MEETING NOTICE – SITE REVIEW COMMITTEE

RE: 4193 Hillcrest Dr., HB-712; New 58,047 sf Addition to Public School Building and Associated Site Improvements

ISSUE: Discussion and action on request for a 58,047 sf., school addition and associated site improvements

RECOMMENDATION: Staff recommends approval subject to any conditions the Committee may identify.

Sheet Number:
C2.0

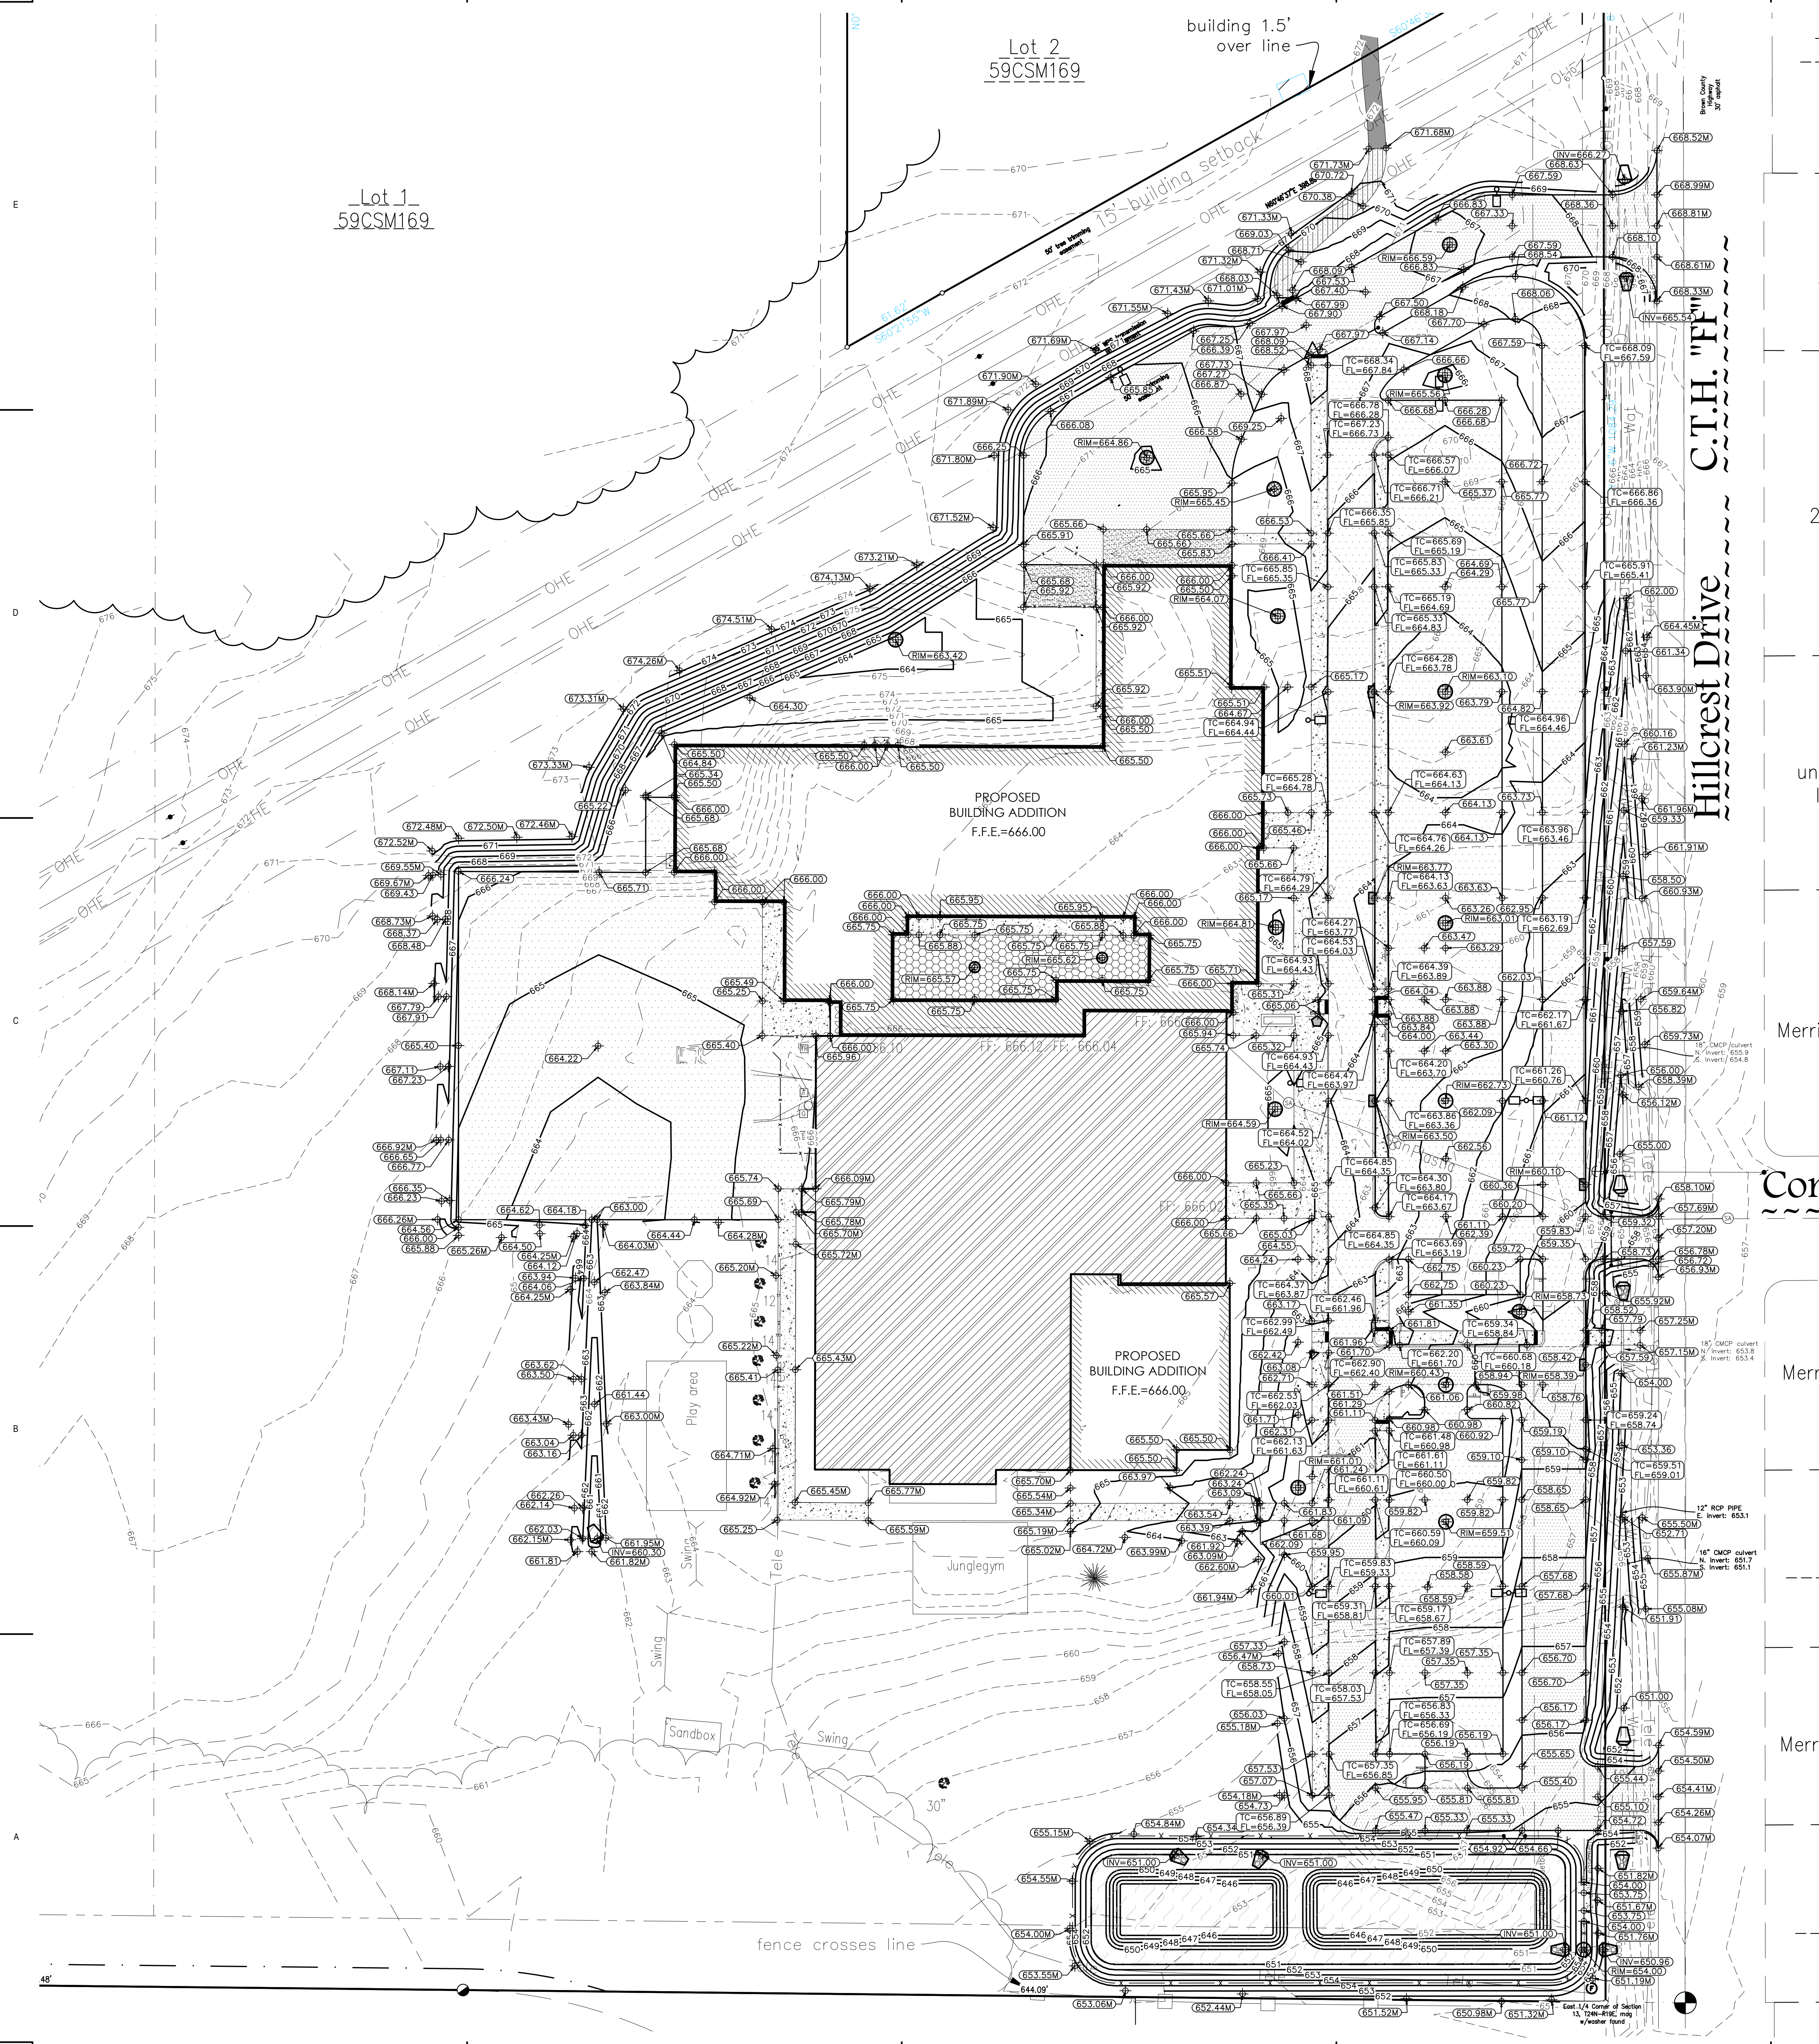
building 1.5'
over line

DUMPSTER ENCLOSURE

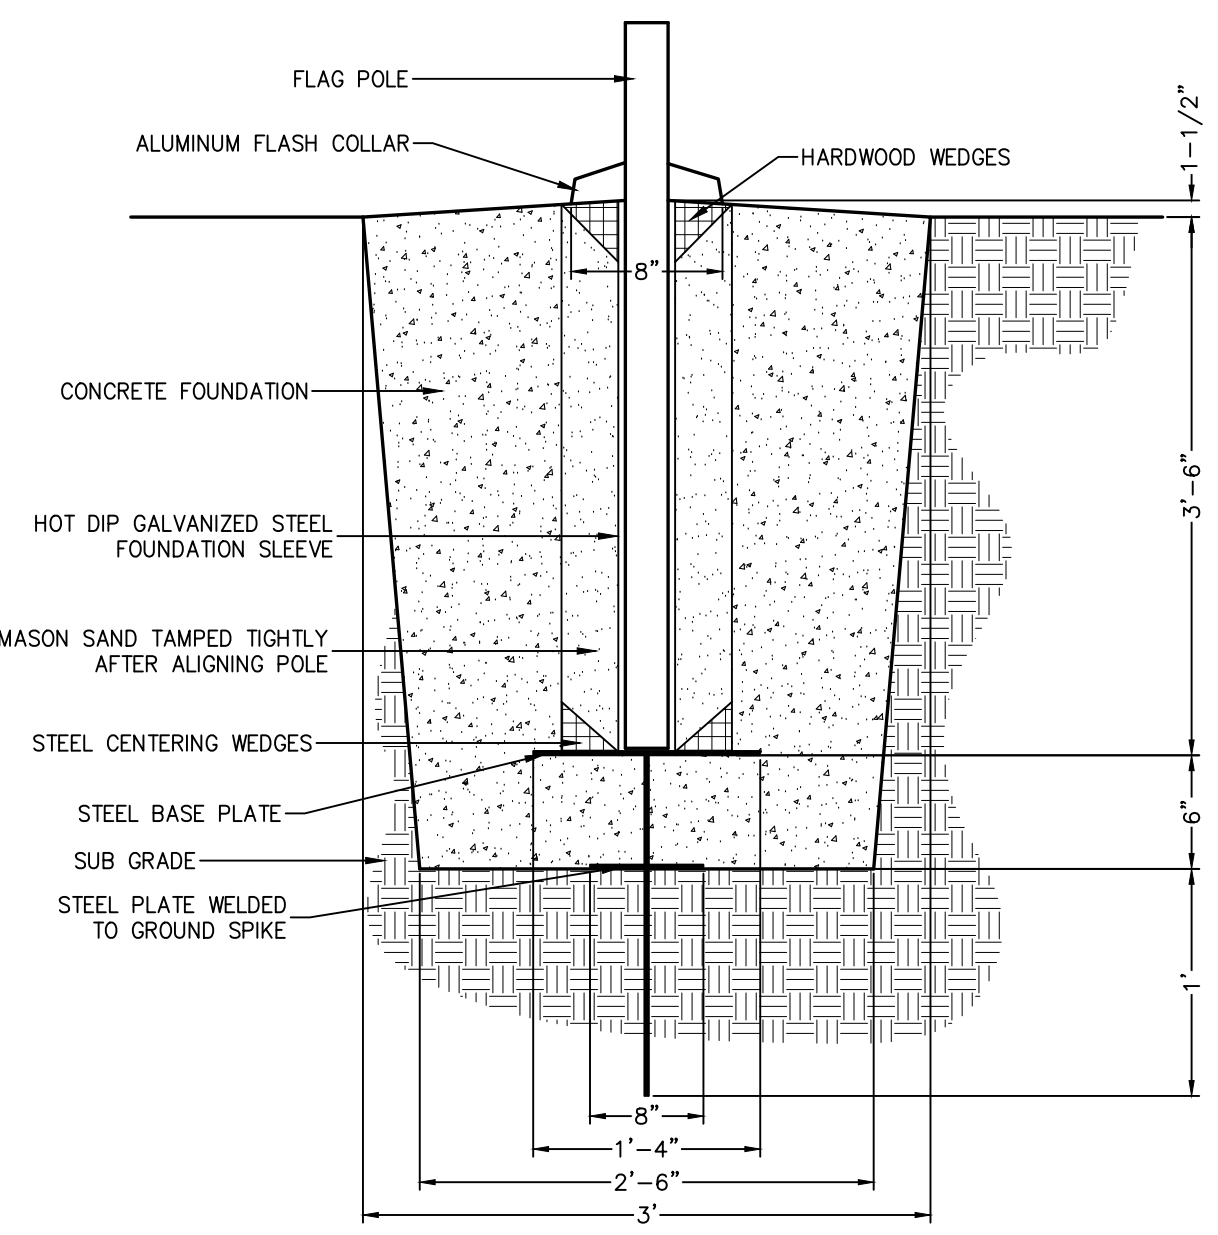
M. Refuse Collection: A new trash/recycling enclosure is planned to be constructed of a chain-link fence with privacy slats at the northwest corner of the proposed addition.

1. Storm water plan shall be approved by the Village Engineer;
2. Screening of any proposed roof mounted HVAC equipment with materials similar to those utilized for the principal building, or landscaping if such equipment is located on the ground;
